Evidence Book 13

Township of Guelph/Eramosa Noise Impact Review Document Book

Noise Impact Review Document Book Index

**Re: Peer Review, Acoustical Study
Hidden Quarry
Novus Project No. 12-0258**

Fig 1.1A

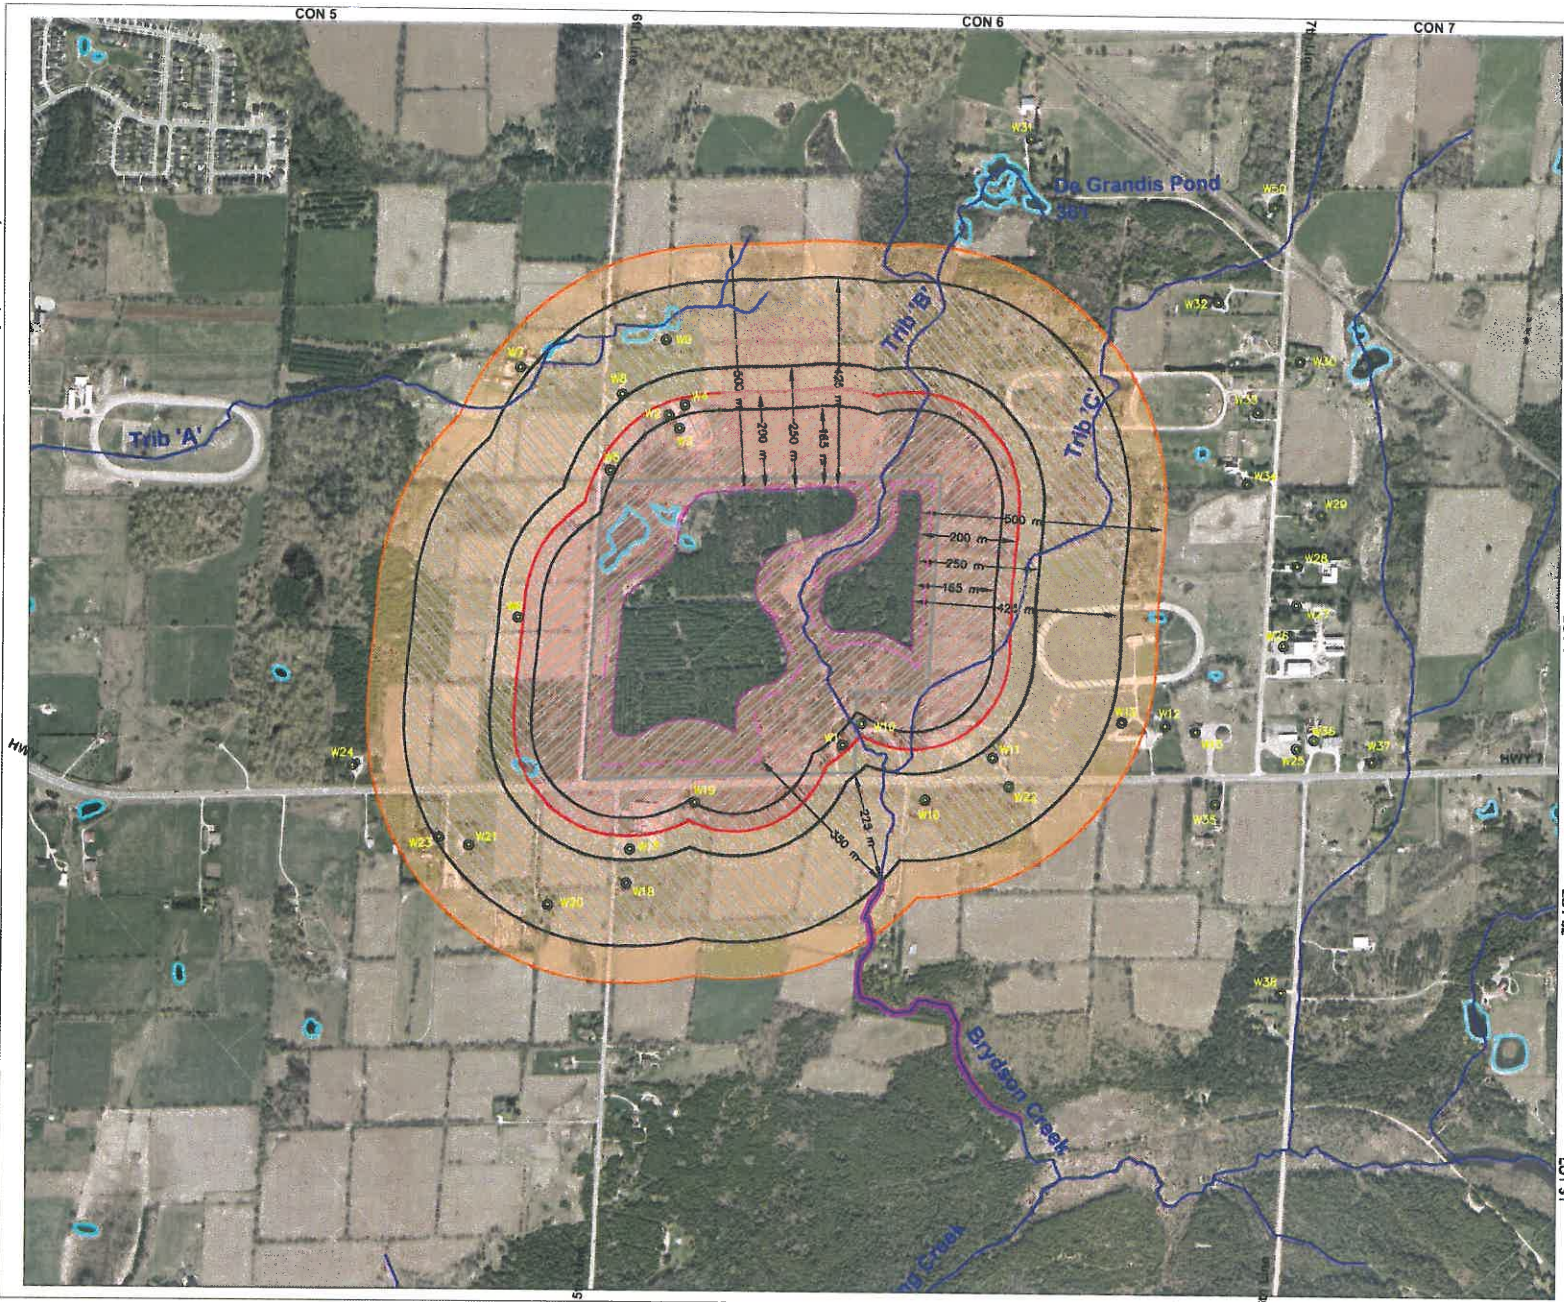
In addition, potential extraction within the 165 m receptor R16 setback limits will encroach on the 400 m buffer distance and have adverse implications for Brydson Creek Brook Trout spawning areas (Fig 1.1A). It is unclear from the Site Plan if the 165 m Blasting Impact Analysis line is the true extraction limit. The Site Plans (pg 3) state

The 250 m encroachment distances need to be shown on the Site Plan together with the note below. Site Plan notes should state what these special precautions might be (see also Golder October 1, 2014 and Hill January 31, 2015) (Fig 1.1A).

- Fig 1.1A** Various Blasting and other Buffer Zone distances contained in the Applicant documents and Peer Reviews have been superimposed on the Hunter Hidden Quarry base mapping. Domestic well sites included. The spring fed pond at the Brydson Creek headwater is 225 m from the licence limit, 350 m distant from the overburden extraction limit and 425 m from the bedrock extraction limit. Bedrock extraction into the 165 m R16 (W19) receptor setback limit as implied on the Site Plans will reduce the buffer limit from the Brydson Creek headwater.

Fig 1.2

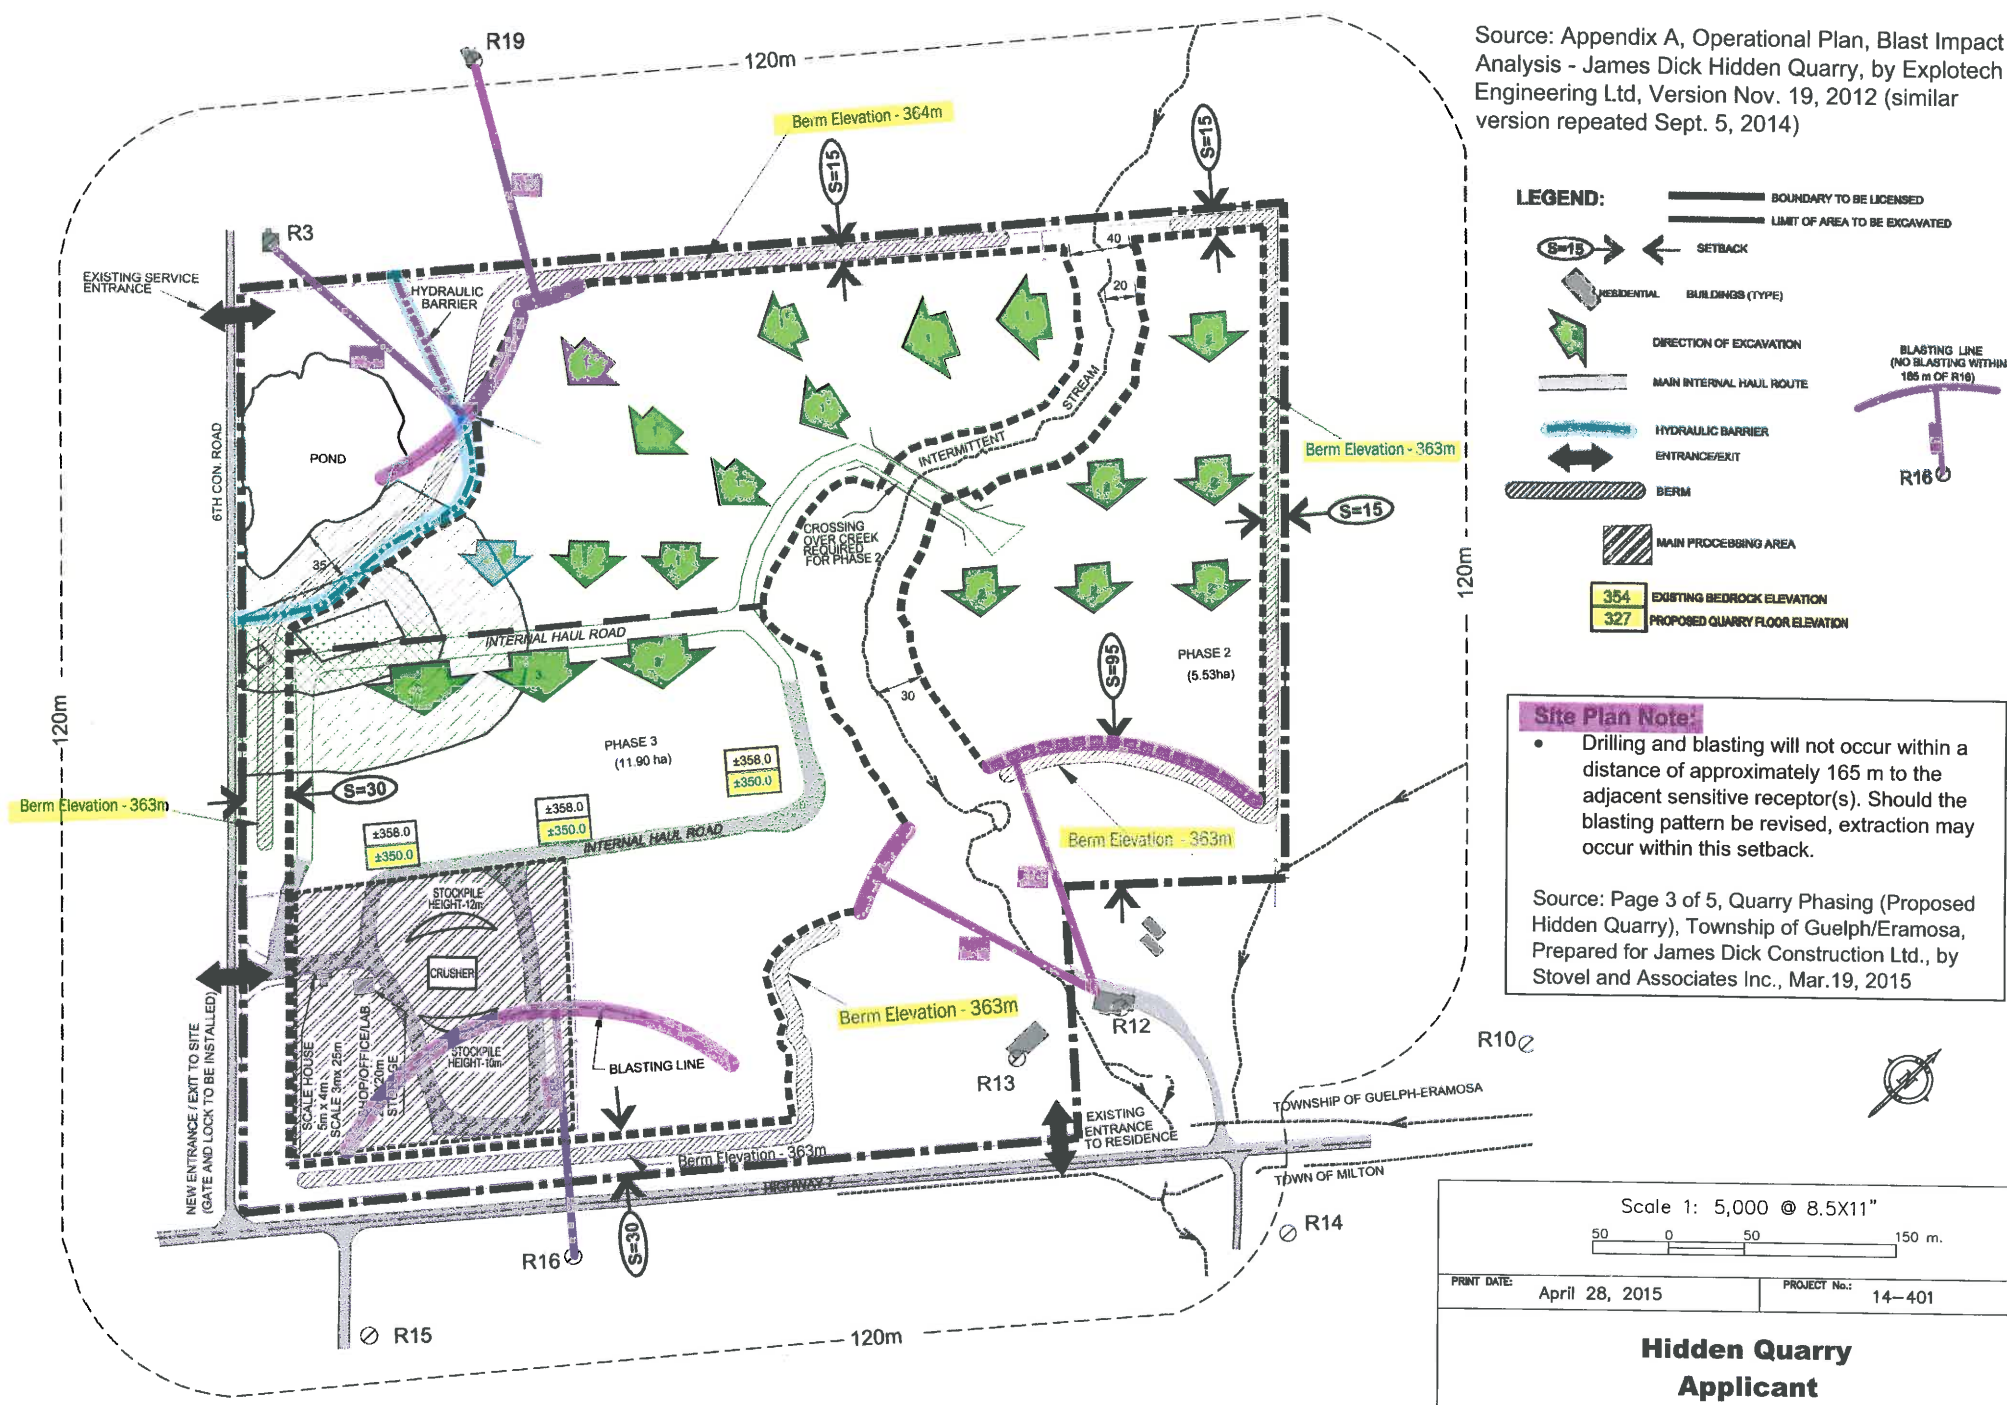
- Fig 1.2** Fig 1.2 shows the direction of extraction (excavation) and Blasting Limit lines as recommended by the Applicant Blasting Study. The Site Plan Note contradicts the Blasting Line Limit (165 m) diagram.

Fig 1.4A

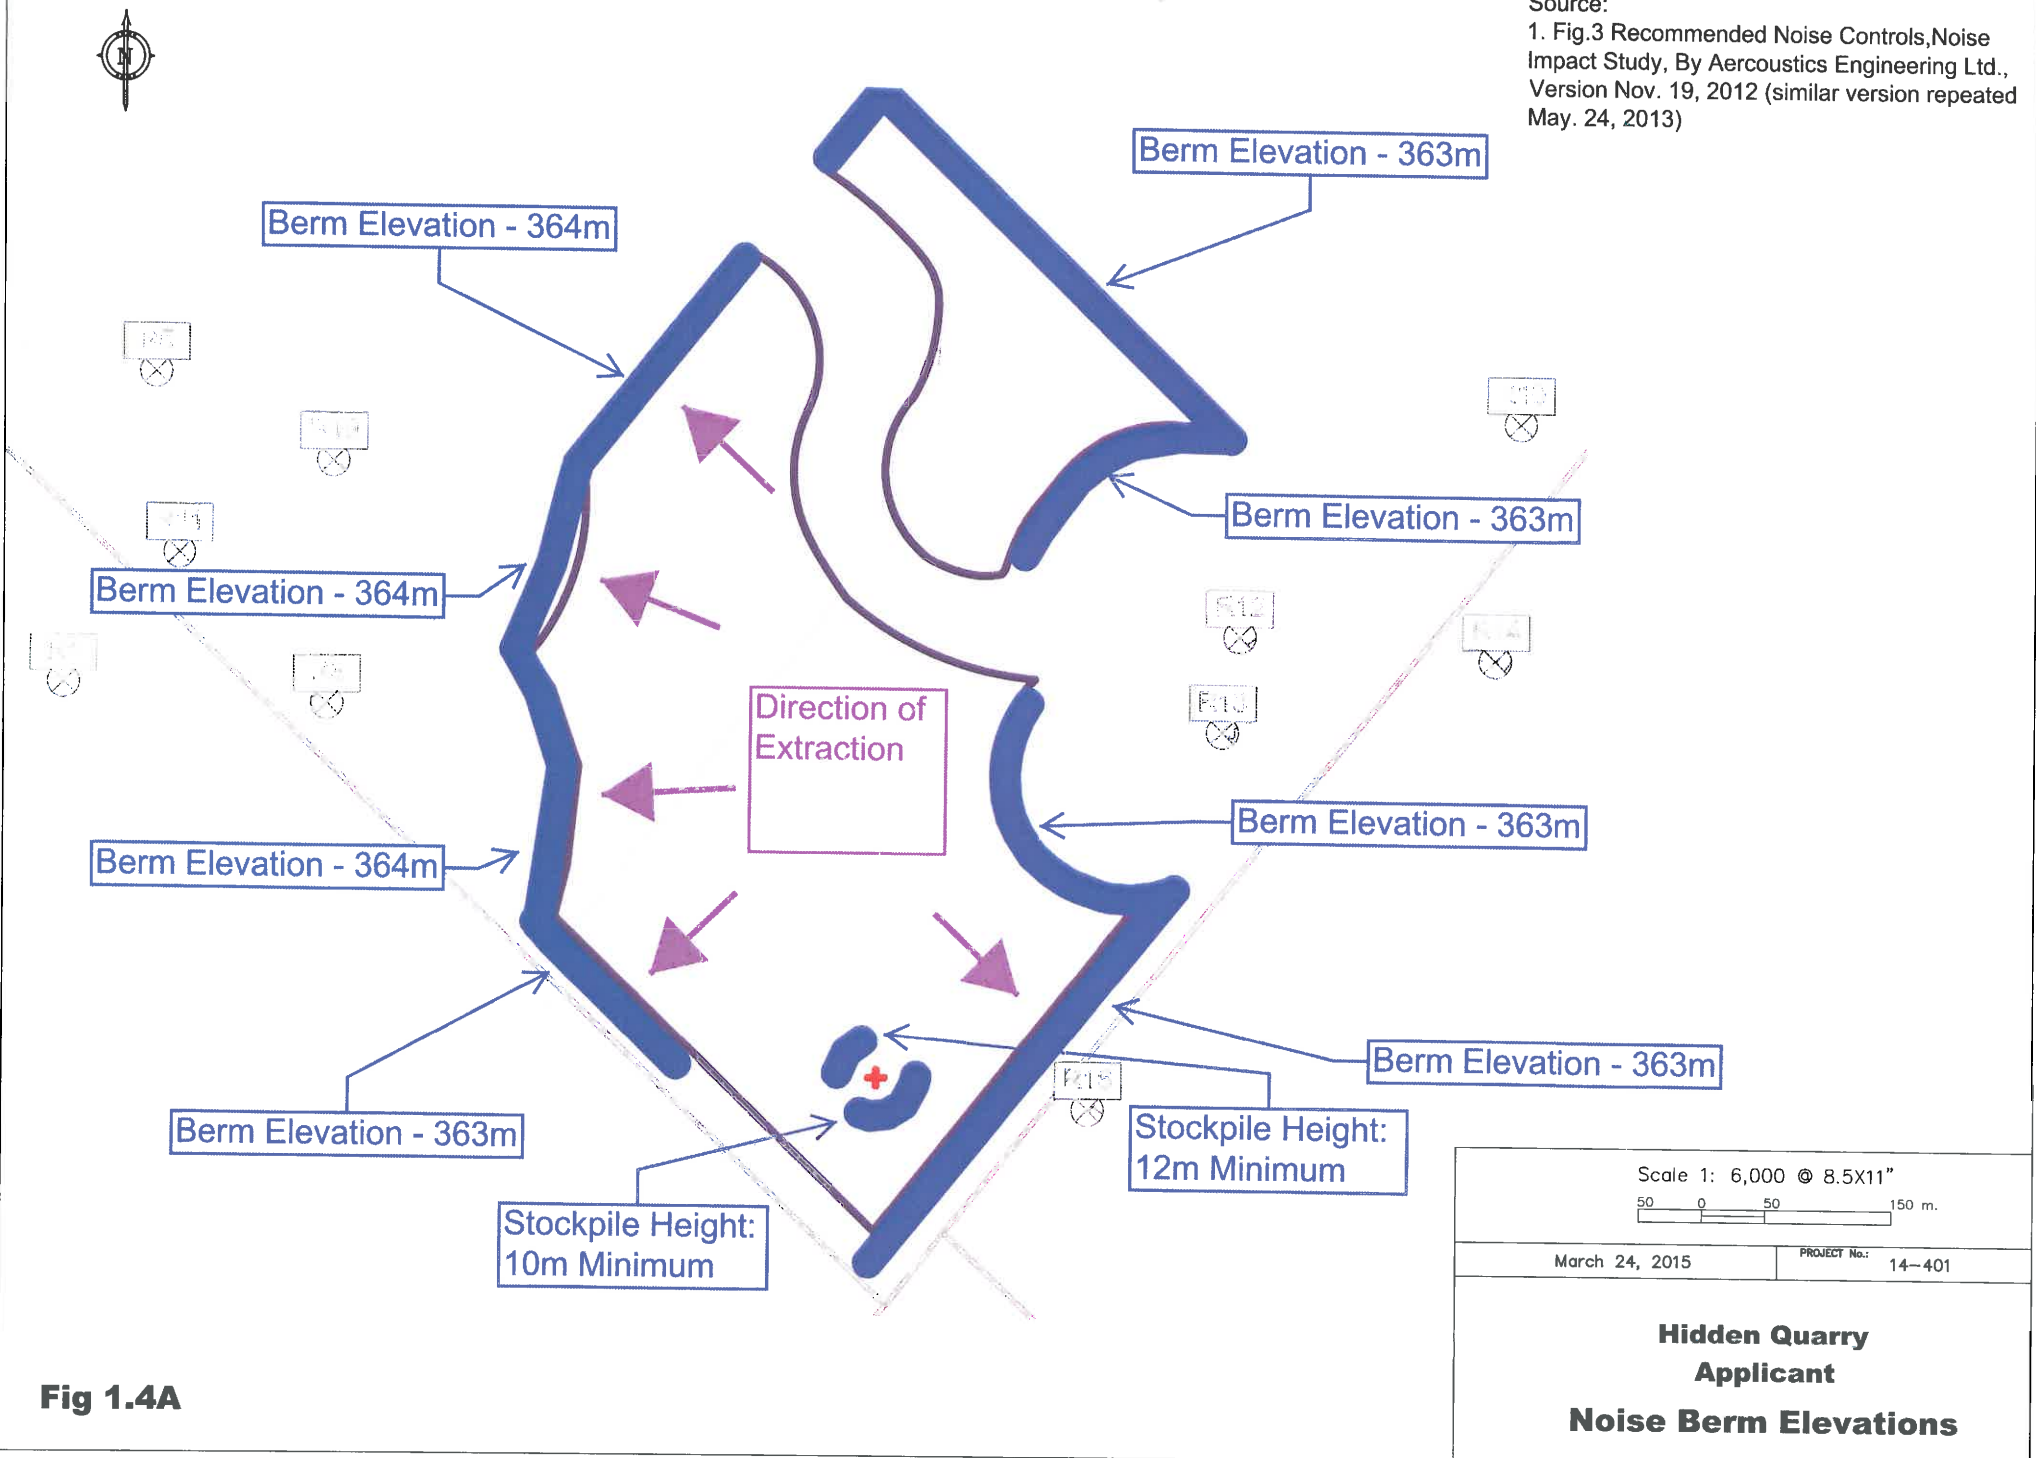
- Fig 1.4A** Fig 1.4A shows the contradictory directions of extraction in the Applicant's Noise Study compared to preceding Fig 1.2 and 1.3. Fig 1.4A appears to be the authority for the Site Plan top of acoustical berm elevations.

Fig 1.4B

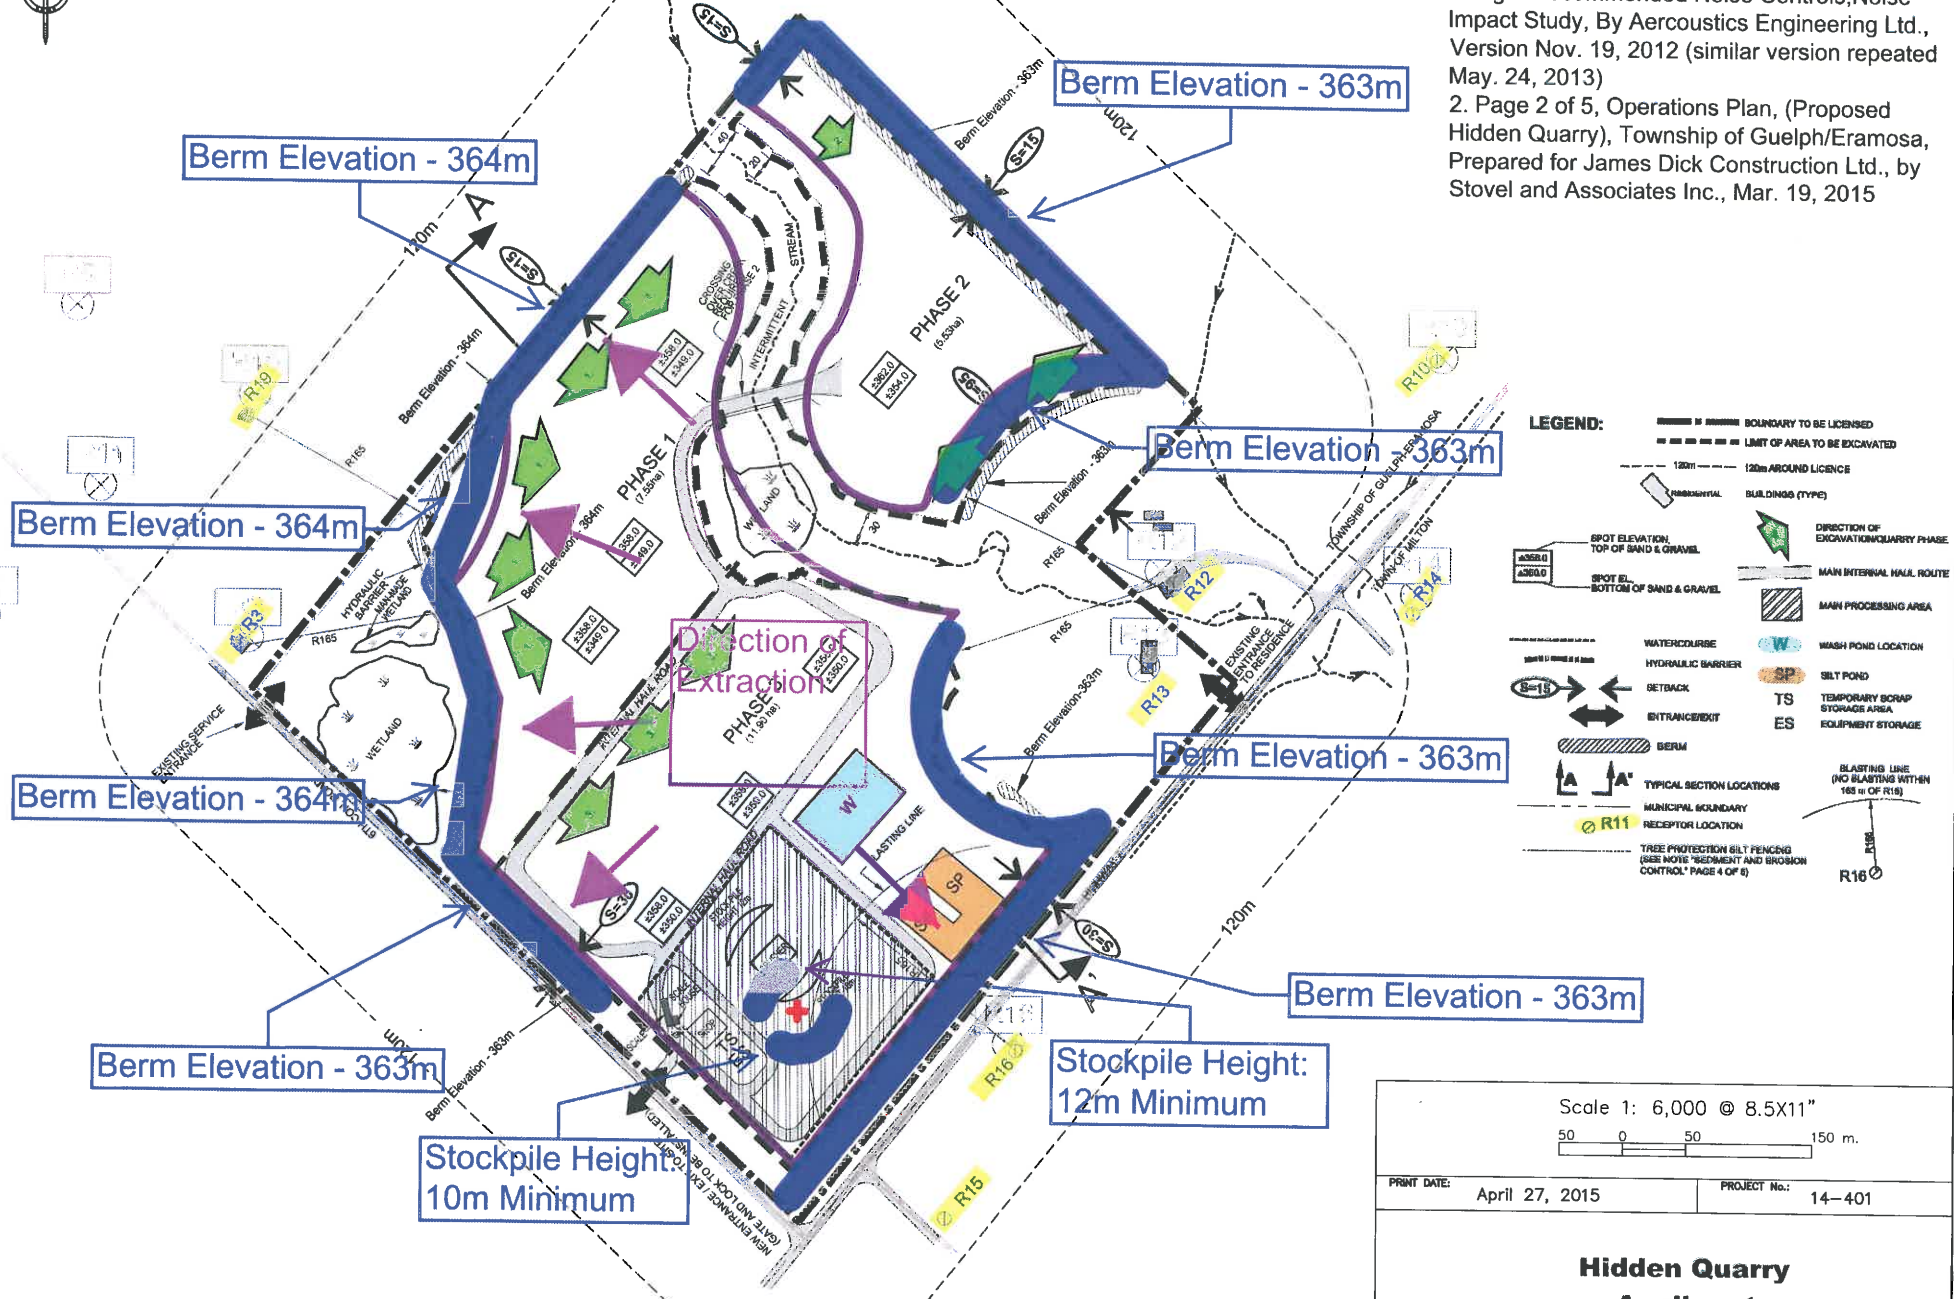
- Fig 1.4B** Fig 1.4B shows the contradictory directions of extraction on the superimposed Applicant Site Plans vs the Noise and Blasting Studies as shown on Fig 1.2, 1.3 and 1.4A.
